## Stage 01: Modification Proposal

# GC0118:

**Mod Title:** Modification to the Grid Code to accommodate the recent Distribution Code modification to Engineering Recommendation P28 – *Voltage fluctuations and the connection of disturbing equipment to transmission systems and distribution networks in the United Kingdom.*

Figure CC.6.1.7 Time and magnitude limits for a category 3 Rapid Voltage Change

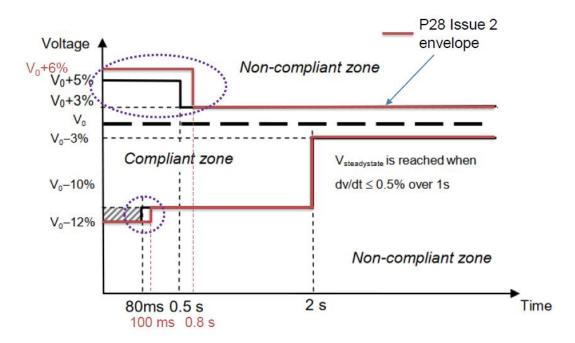
The difference between the voltage envelope for Rapid Voltage Changes in Figure CC.6.1.7 of the Grid Code and Table 4 of EREC P28/2 Issue 2 for Very Infrequent

RVCs are shown in the above figure. The P28 Working Group has proposed limits for RVC in EREC P28 Issue 2 that:

- generally align with those in Figure CC.6.1.7 for reductions in voltage.
- are absolute and compatible with EREC G59 and grid connected protection as well as TGN 288 for overvoltage.
- are compatible with immunity levels for customer equipment.
- should not result in unacceptable disturbance provided:
  - o events are sufficiently spaced apart.
  - o multiple RVCs are completed within a small time window.
  - o there is no damage to or tripping of customer equipment.
